**COLLEGE OF DUPAGE
REGULAR BOARD MEETING**

Physical Education Center (PEC) Arena Divider Curtains – Bid Rejection

2018-B0044 College of DuPage PE Arena Divider Curtains

ADDENDUM # 3

EXHIBIT C – SPECIFICATION DRAWINGS

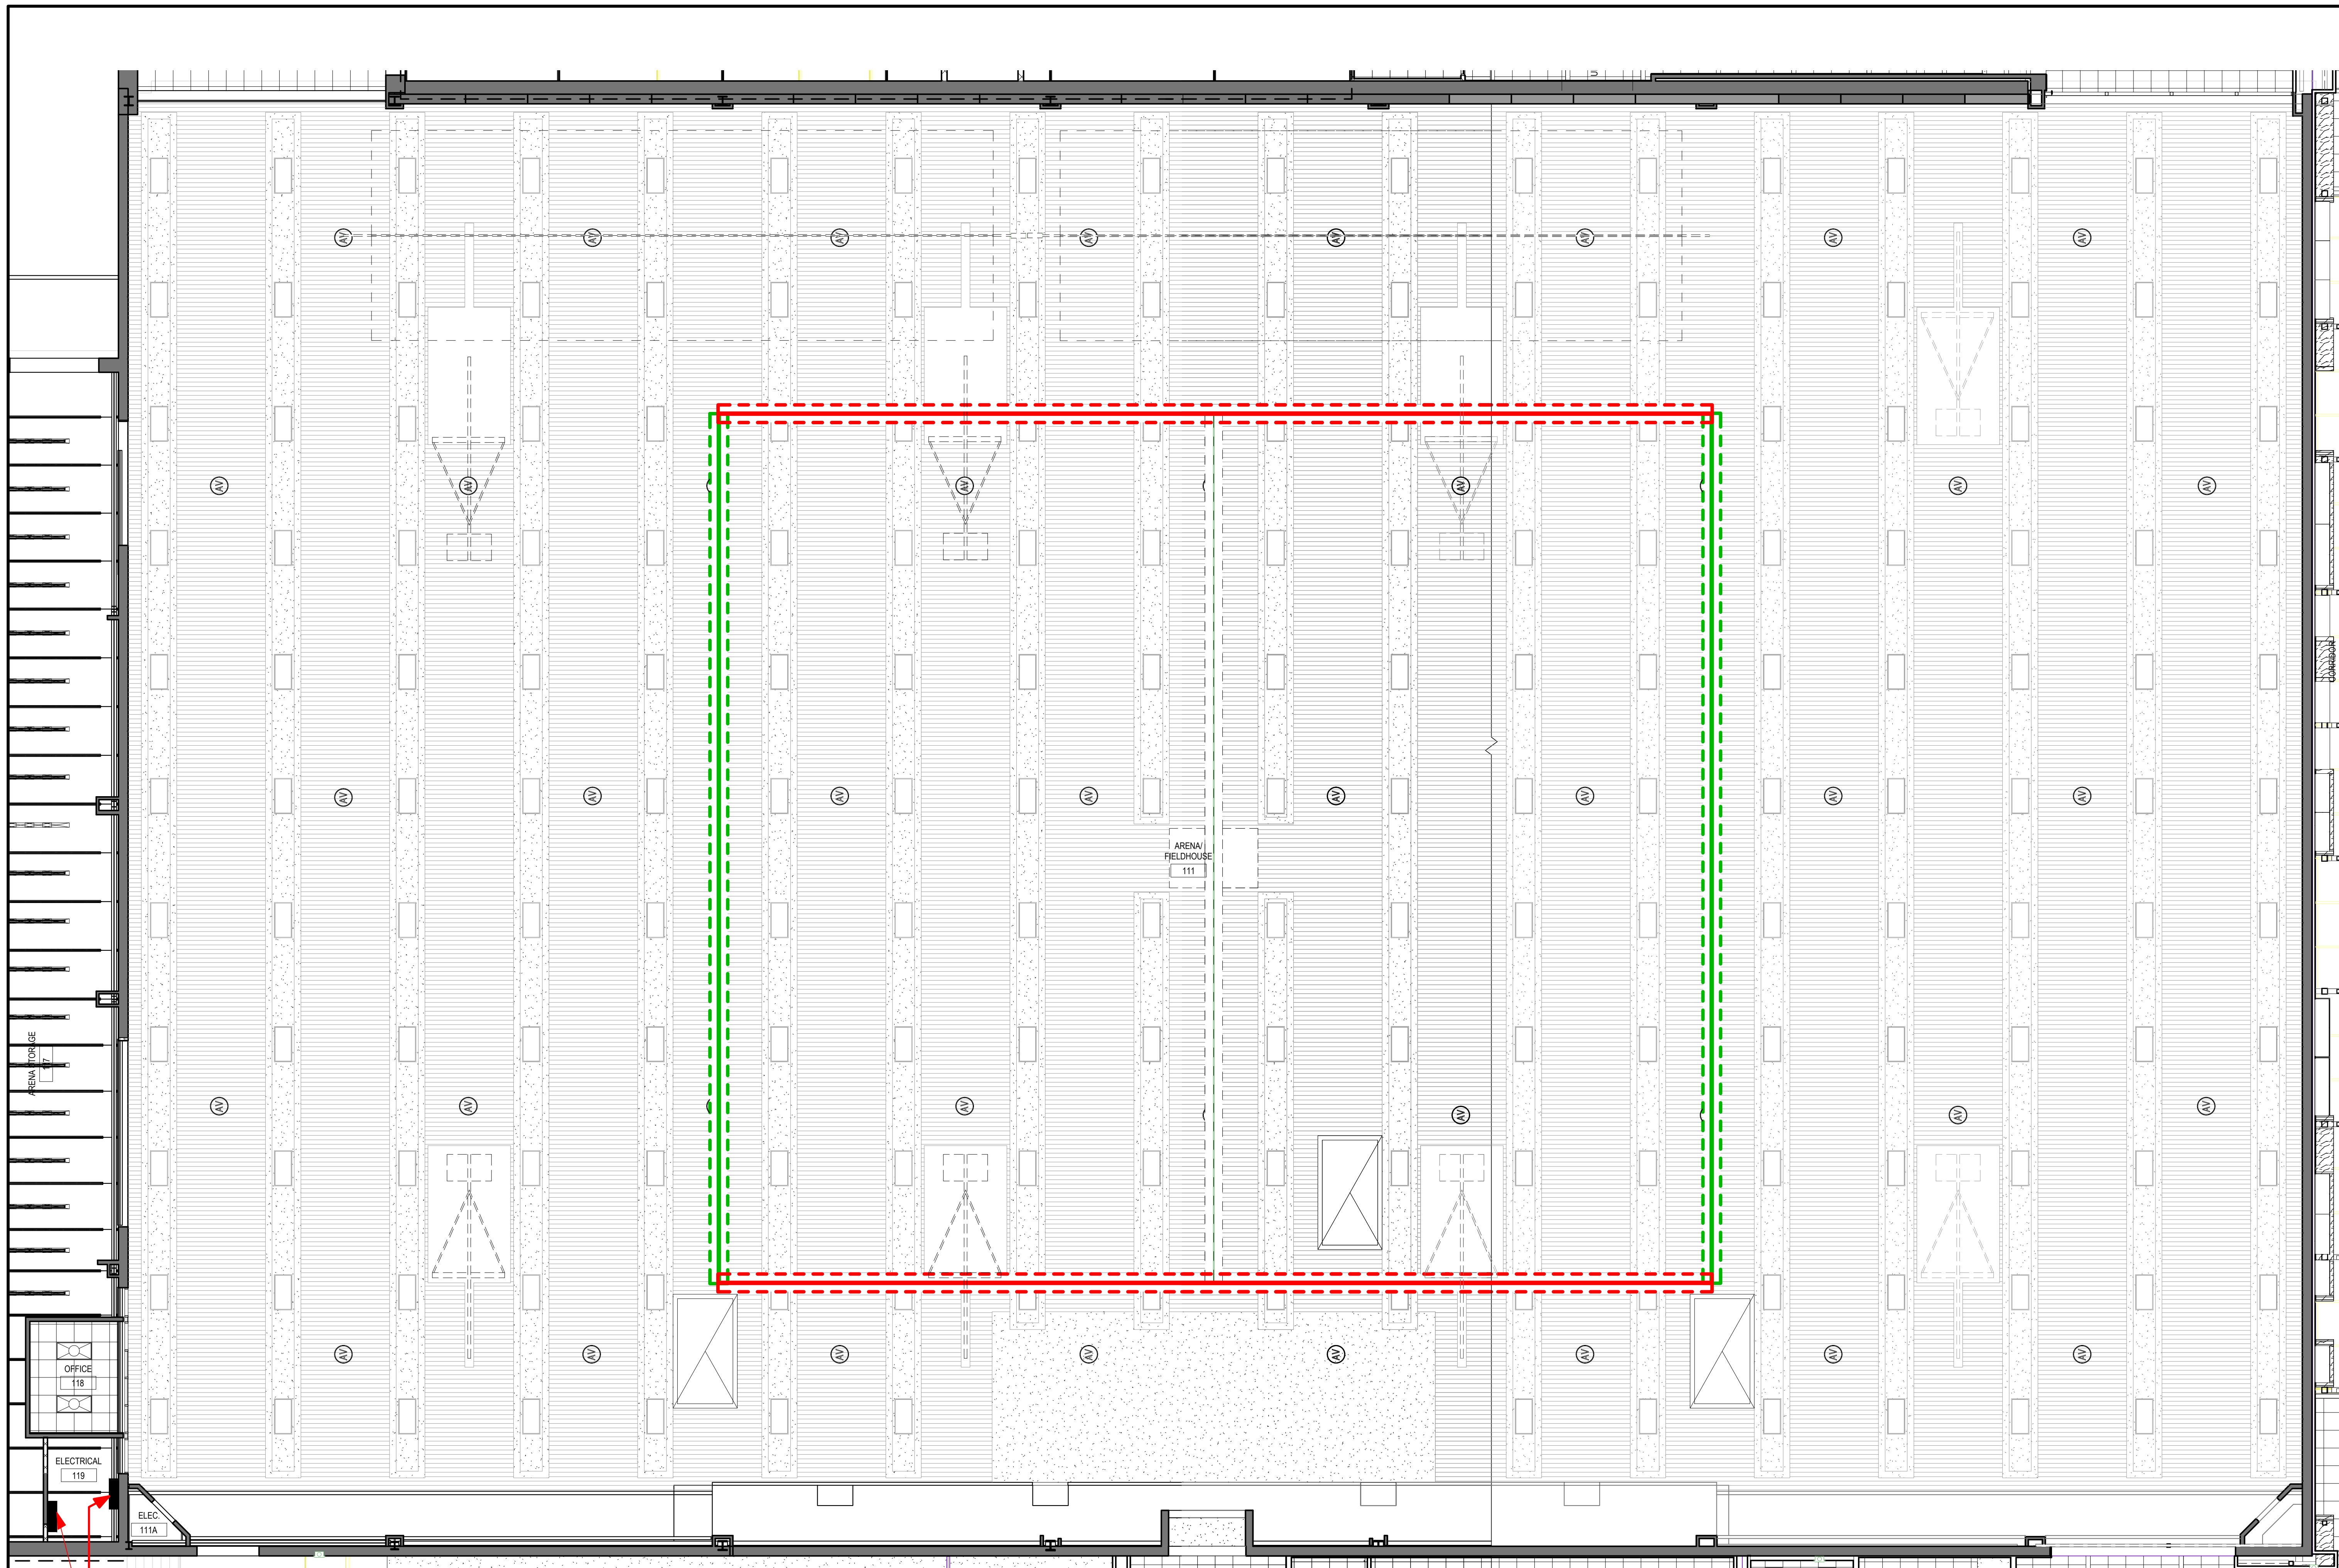
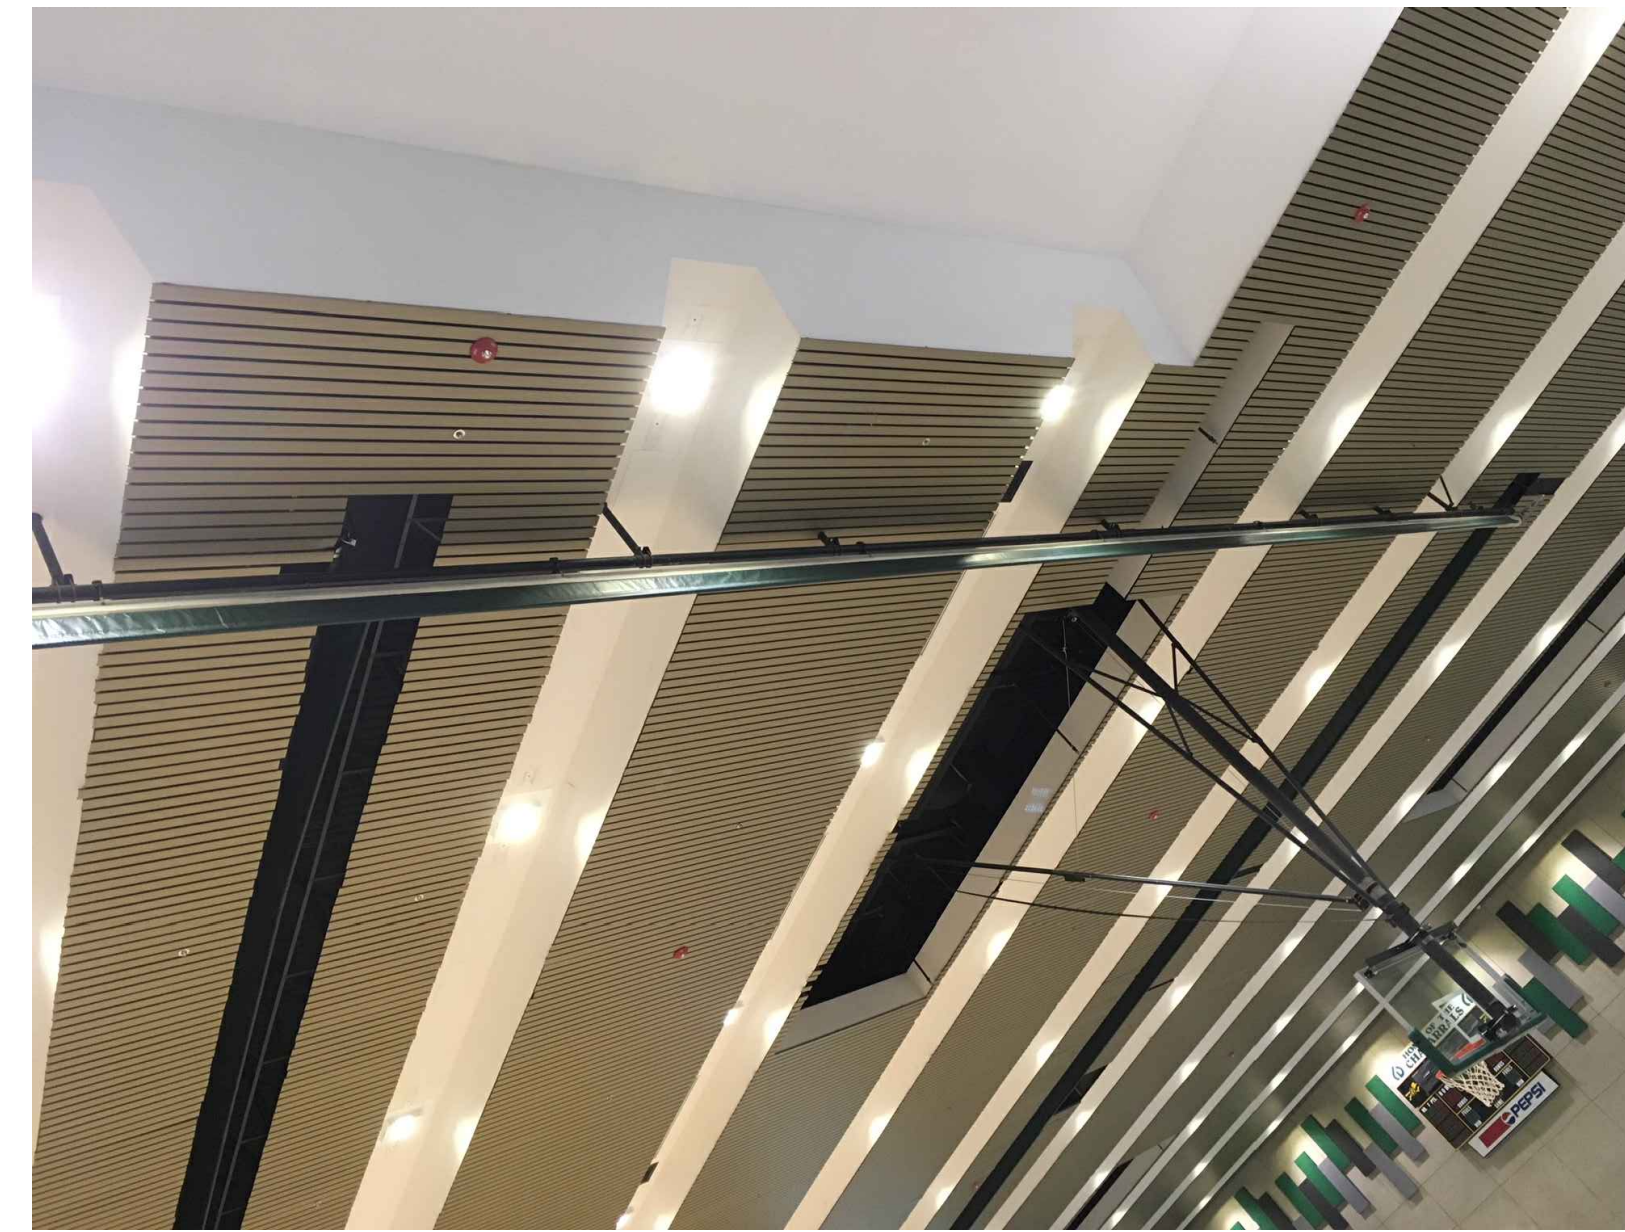
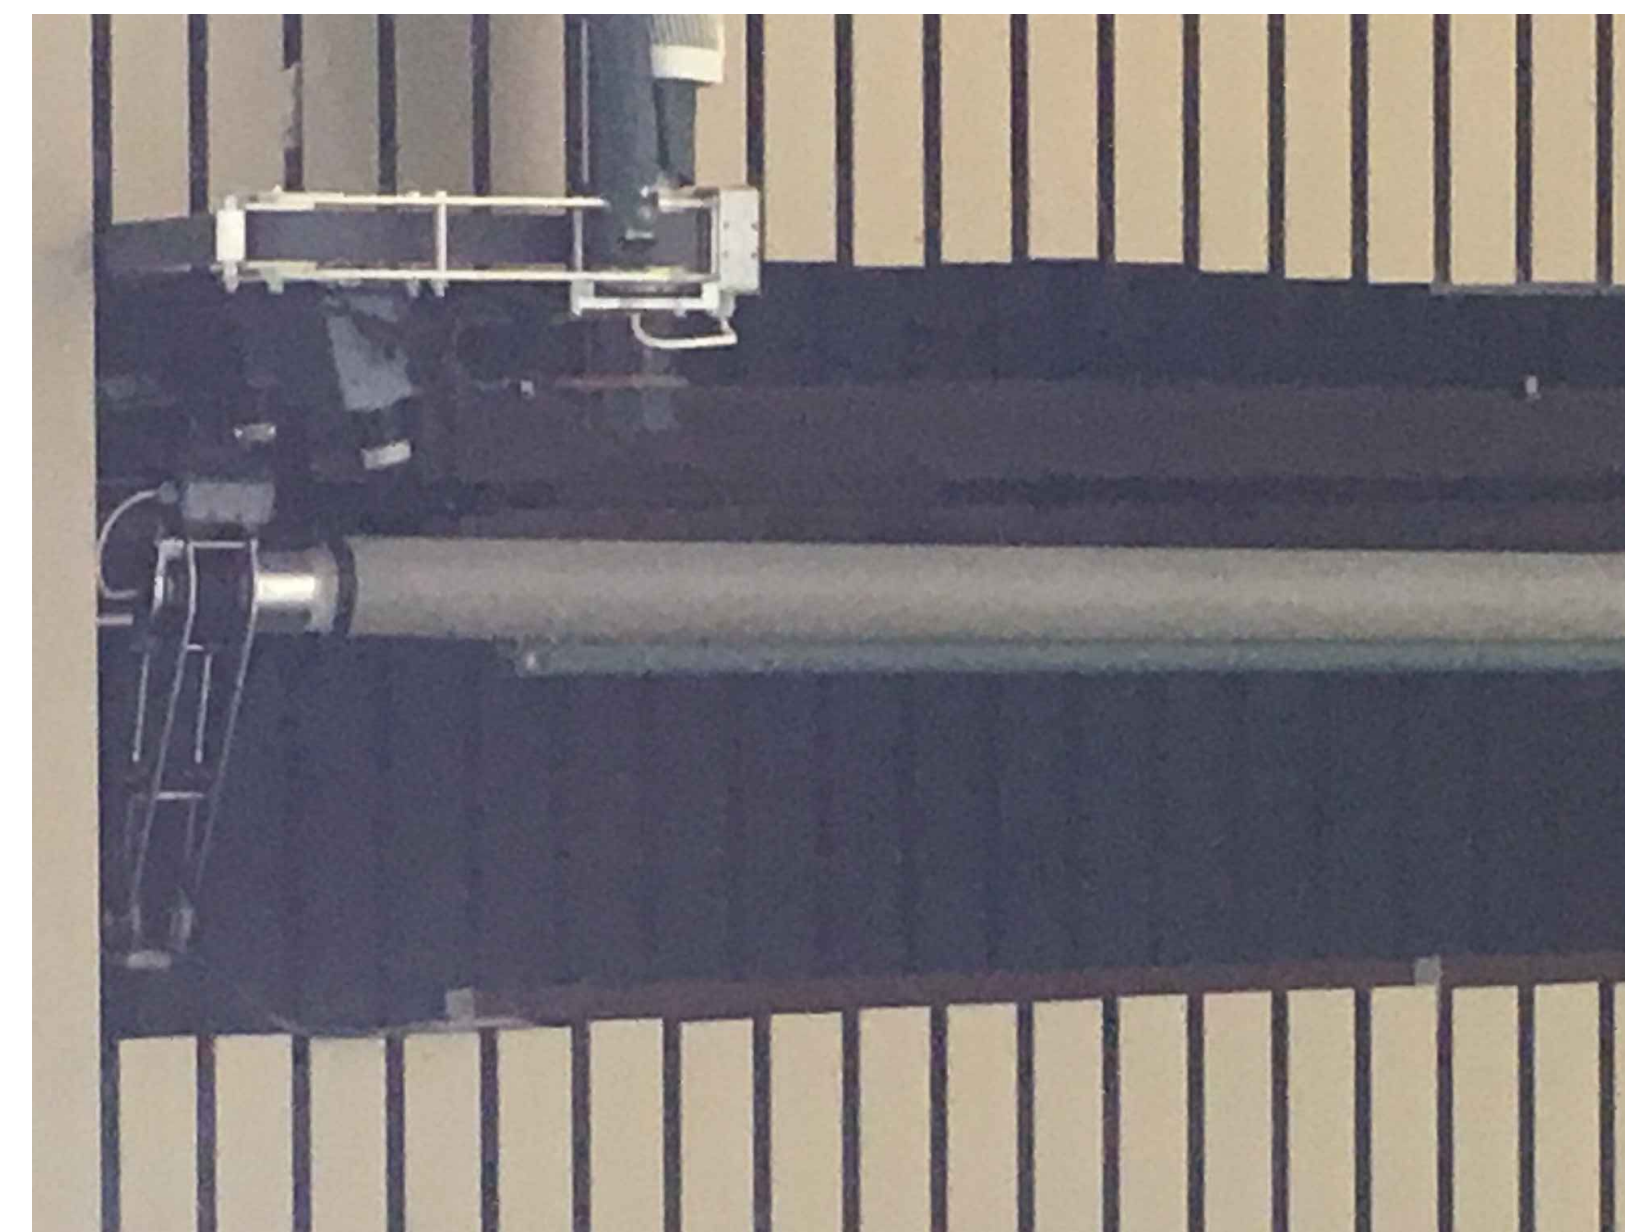
- 1. **Exhibit A, Specification Arena Divider Curtains, Exhibit B, Product Substitution Sheet, and Exhibit C, Specification Drawings, are revised to incorporate the product specification details in Attachment A of this addendum.**

KEY:
--- = TYPE 1 (EAST/WEST) EXISTING BELOW CEILING MOTORIZED CENTER-DRIVE DIVIDER CURTAIN (110' x 30'). MOUNT NEW CURTAIN SYSTEM TO EXISTING STRUCTURAL TUBING.
--- = TYPE 2 (NORTH/SOUTH) EXISTING RECESSED MOTORIZED CENTER-DRIVE DIVIDER CURTAIN (98' x 33'). MOUNT NEW CURTAIN SYSTEM TO EXISTING ROOF STRUCTURE.
